Sundry Notices and Reports on Wells

8. Well Name & Number  
San Juan 27-4 Unit 5

## PLUG AND ABANDONMENT PROCEDURE

Re: Permanent Abandonment  
Well: 5 San Juan 27-4 Unit

## Proposed P&A

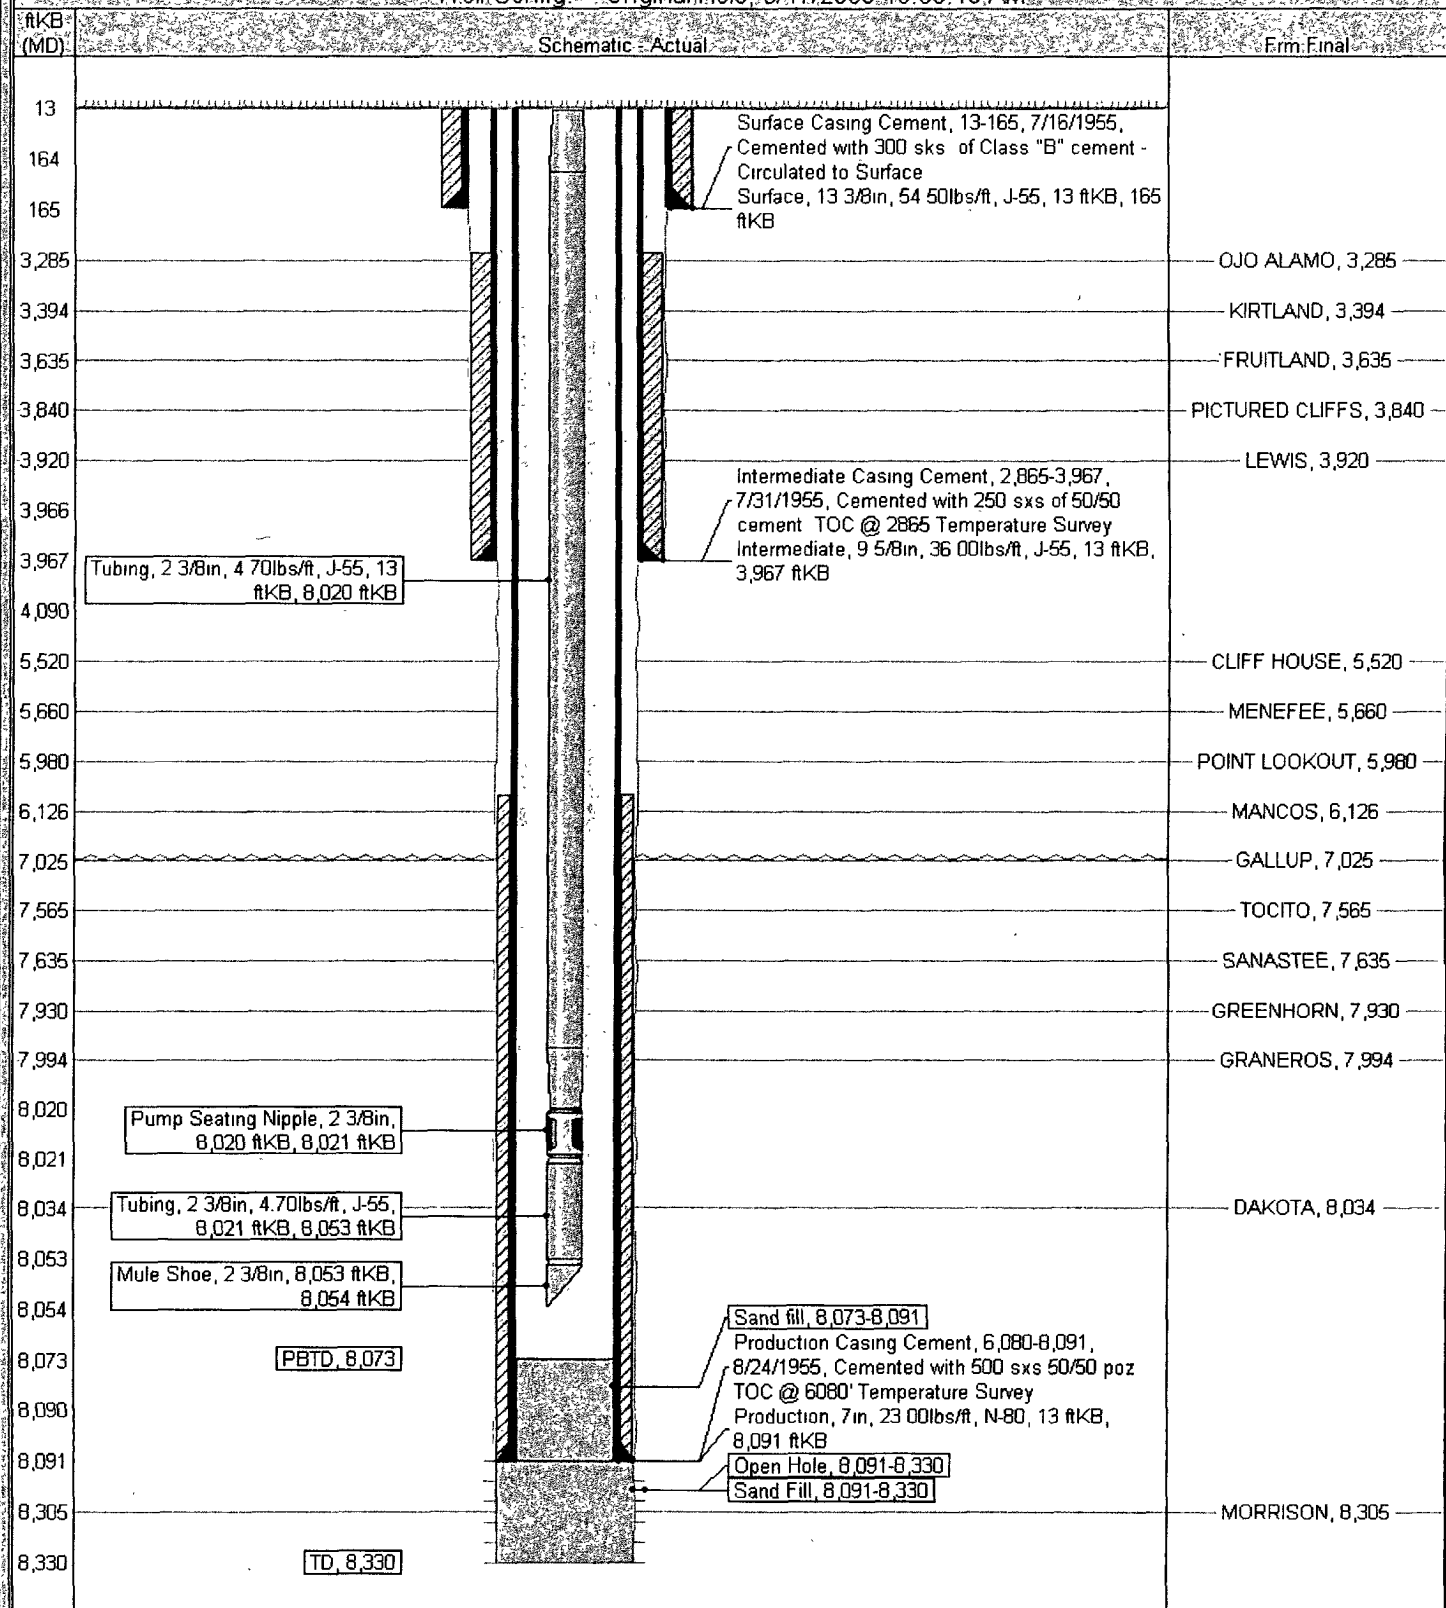
4443
6. **Plug #3 (Mesaverde top, ~~5570'~~ – 5470')**: Perforate 3 HSC squeeze holes at ~~5570'~~. If casing tests, then establish rate into squeeze holes. Set a 7" CR at ~~5520'~~. Establish rate into squeeze holes. Mix and pump 55 sxs cement, squeeze 26 sxs outside casing and leave 29 sxs inside casing to cover the Mesaverde top. TOH with tubing.

2053
8. **Plug #6 (Nacimiento top, ~~2013'~~ – 1913')**: Perforate 3 HSC squeeze holes at ~~2013'~~. If casing tests, then establish rate into squeeze holes. Set a 7" CR at ~~1963~~. Establish rate into squeeze holes. Mix and pump 105 sxs cement, squeeze 22 sxs outside 7" x 9.625" casing, 55 sxs outside 9.625" x 12.25" annulus and leave 29 sxs inside casing to cover the Nacimiento top. TOH and LD tubing.

1. Plugging operations authorized are subject to the attached "General Requirements for Permanent Abandonment of Wells on Federal and Indian Lease."
2. Farmington Office is to be notified at least 24 hours before the plugging operations commence (505) 599-8907.
3. The following modifications to your plugging program are to be made:
  - a) Place the Mesaverde plug from 4443' – 4343' inside and outside the 7" casing.
  - b) Place the Pictured Cliffs/Fruitland plug from 4017' - 3560' inside and outside the 7" casing.
  - c) Place the Kirtland/Ojo Alamo plug from 3444' – 3161' inside and outside the 7" casing.
  - d) Place the Nacimiento plug from 2053' – 1953' inside and outside the 7" and 9 5/8" casings.
